**ADDENDUM NO. 1**

Project: **STEPHENSON SCHOOL BUILDING & PARKING IMPROVEMENTS**

Owner: **City of Dripping Springs, Texas**

Date: **July 8, 2025**

3 East Ramp Detail Section  
1" = 1'-0"

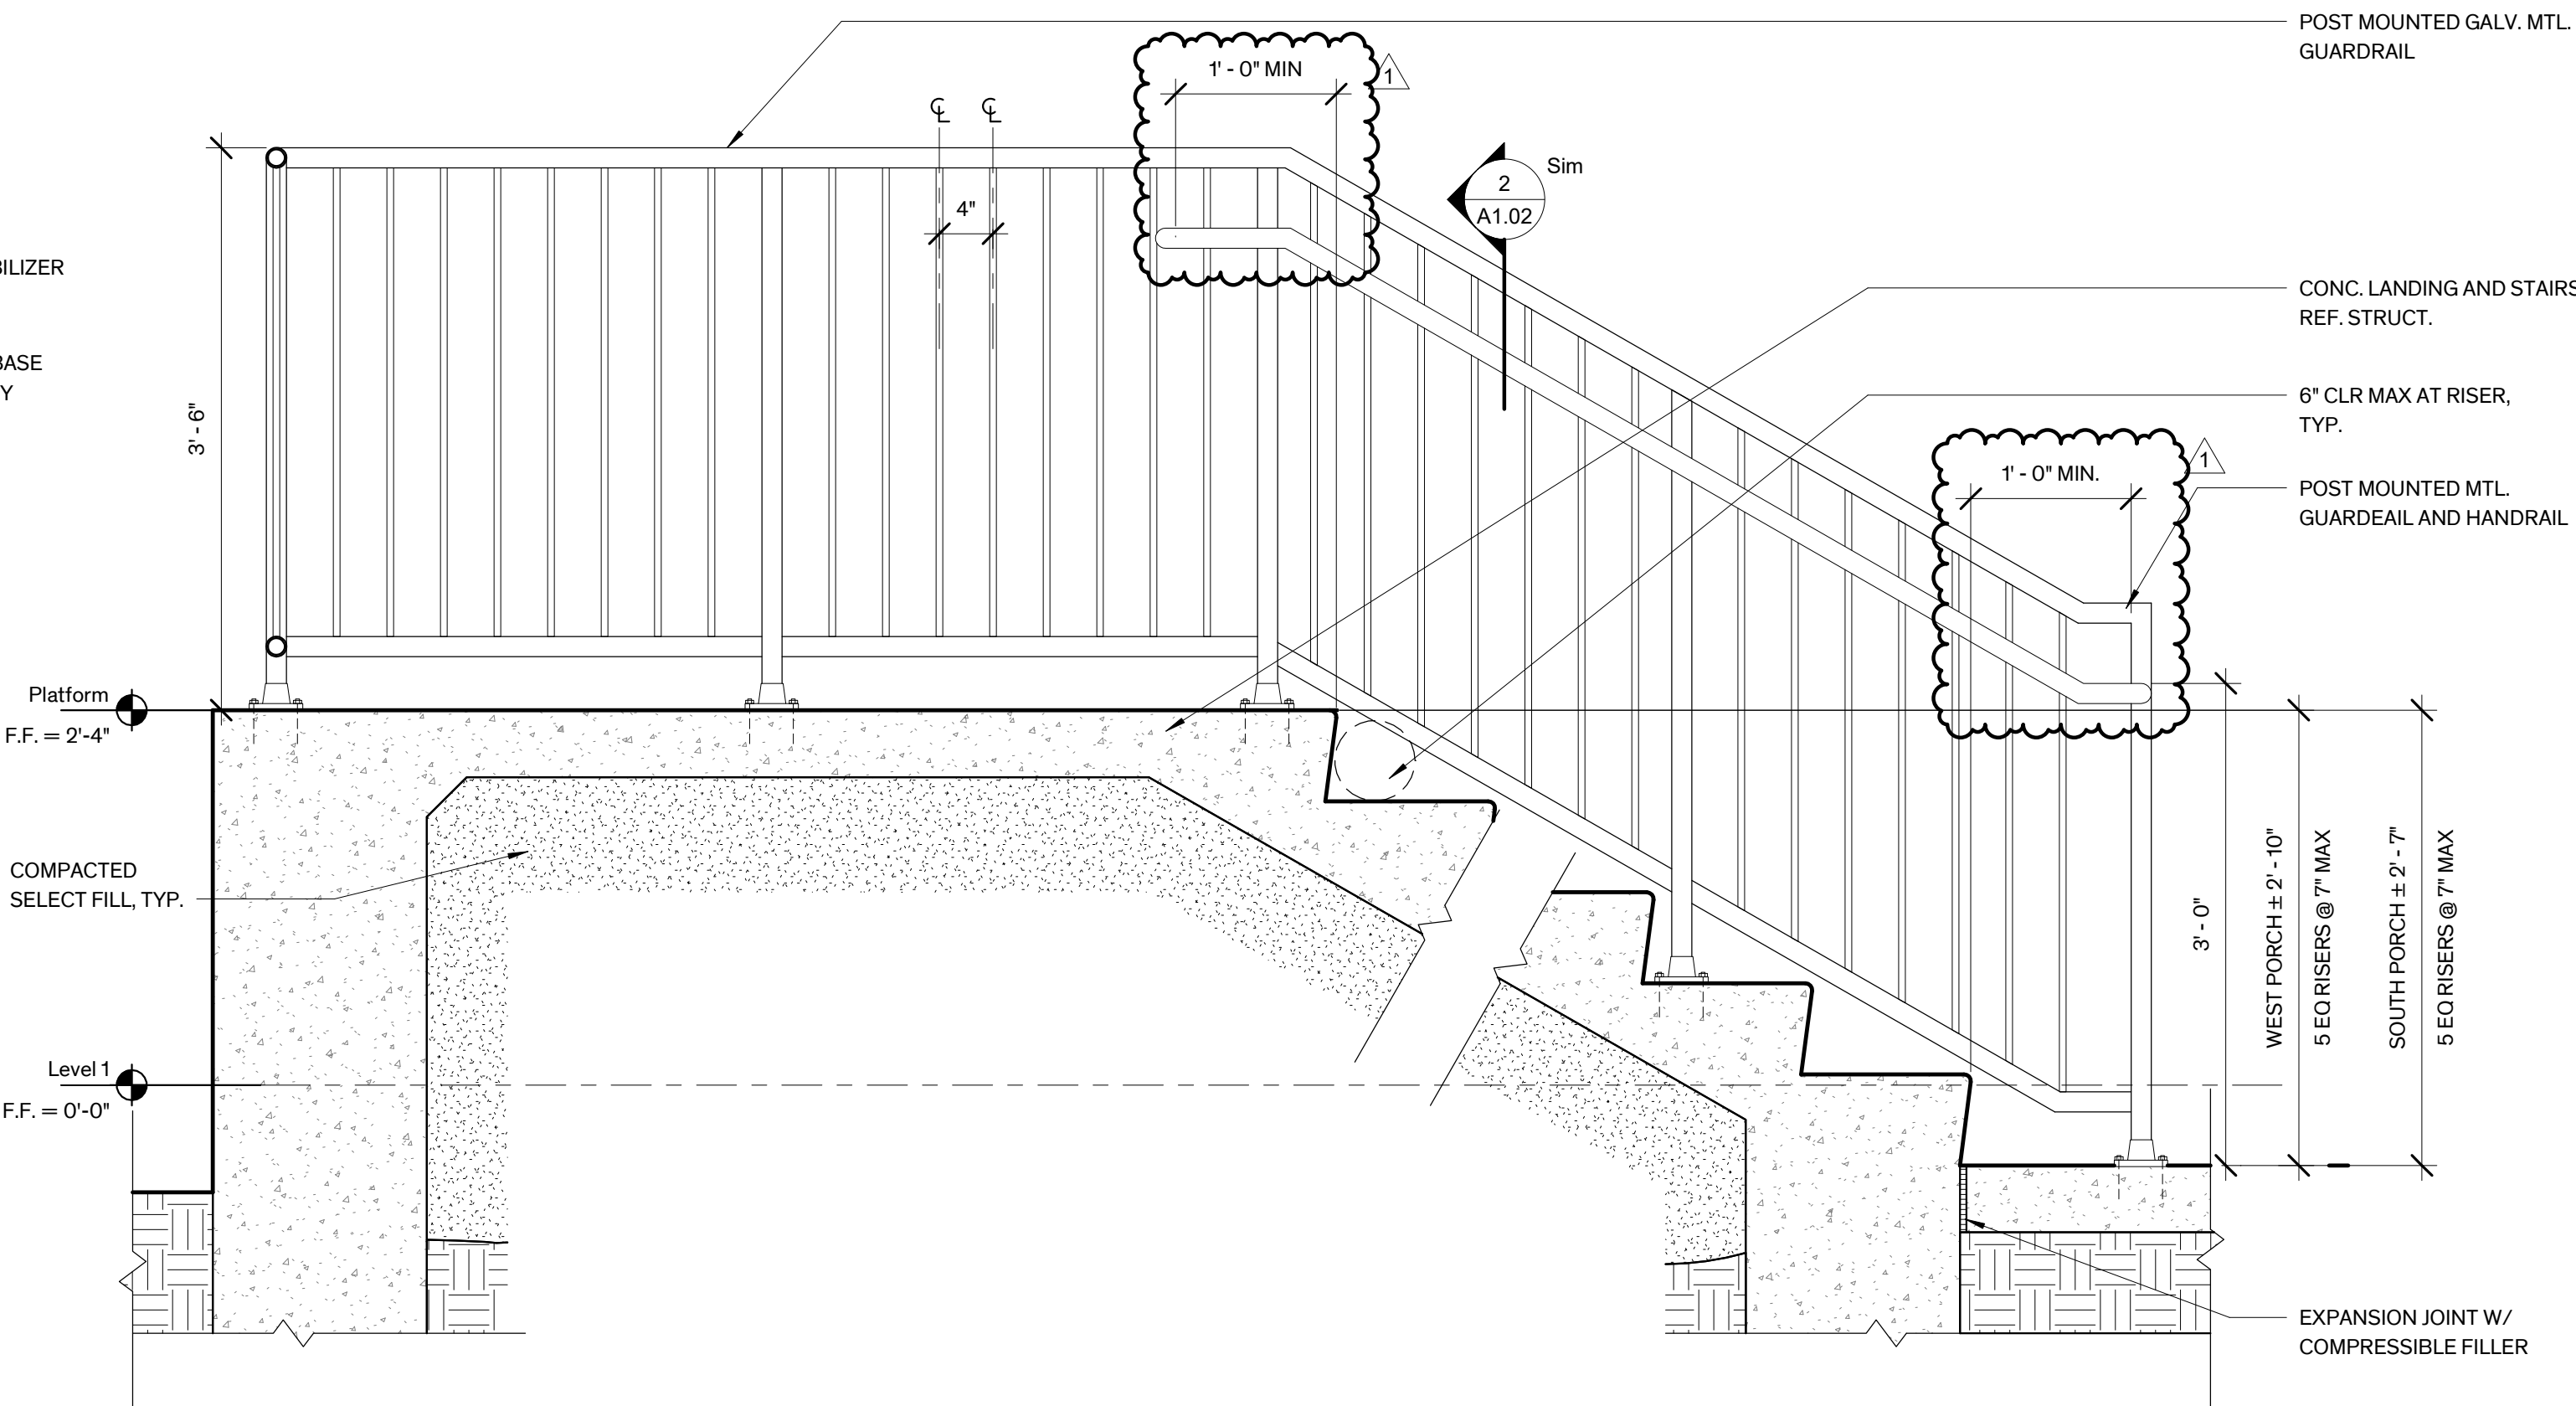
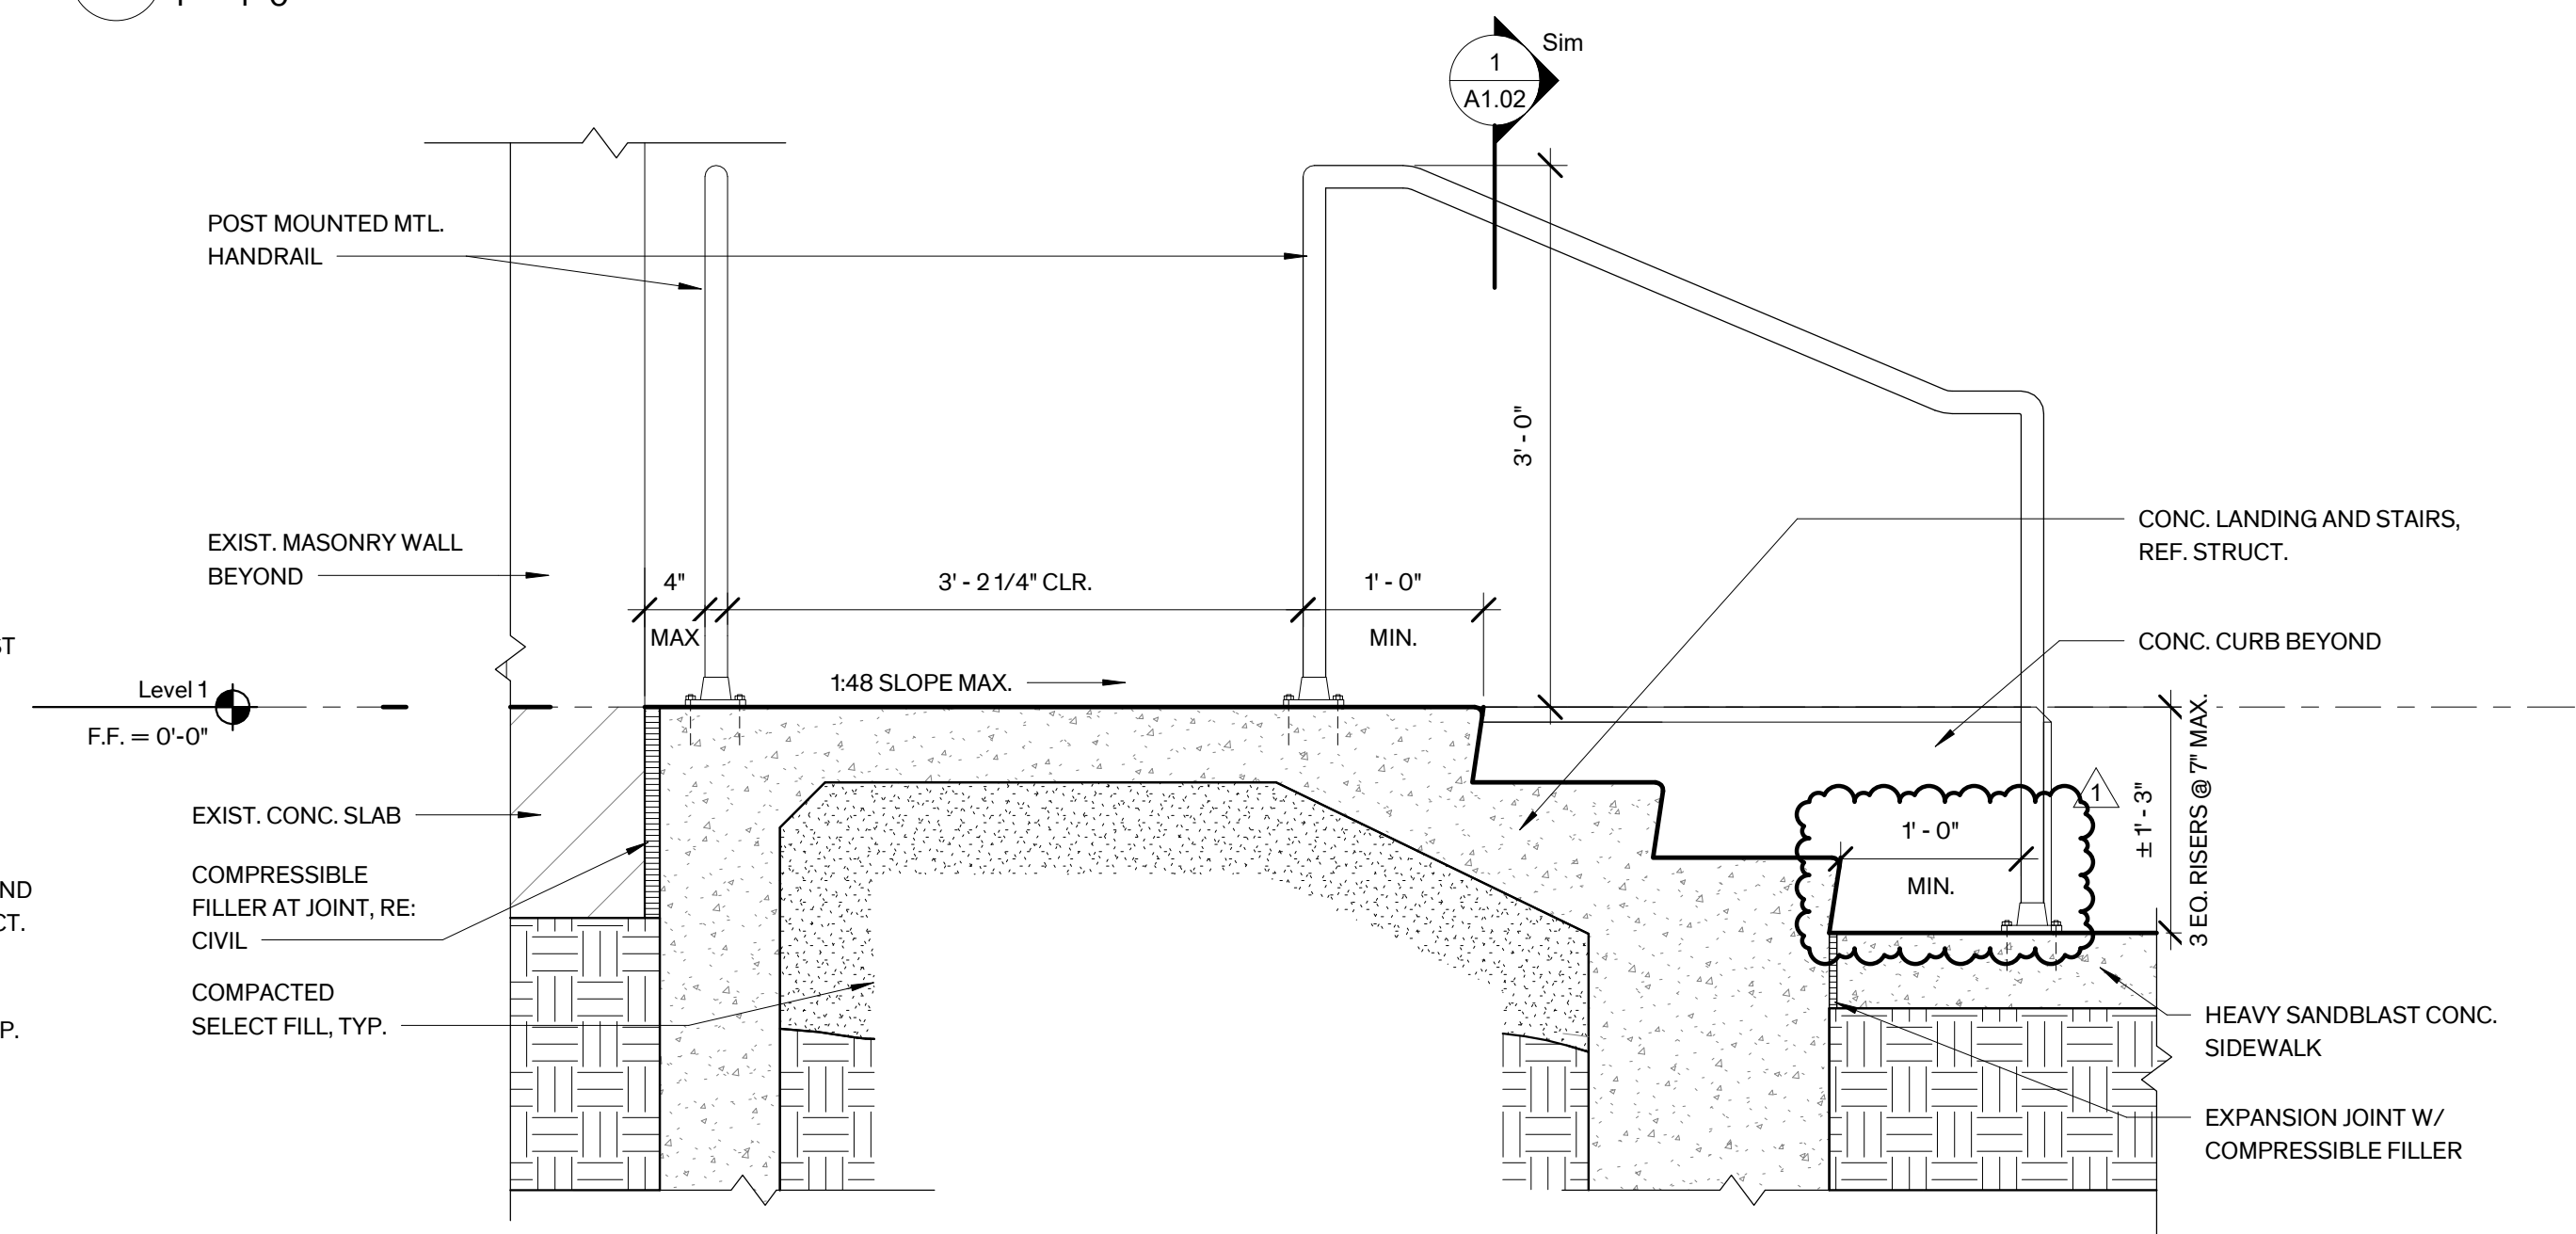
UPDATE – Update handrail dimensioning to show 12 inch extension to back of railing.
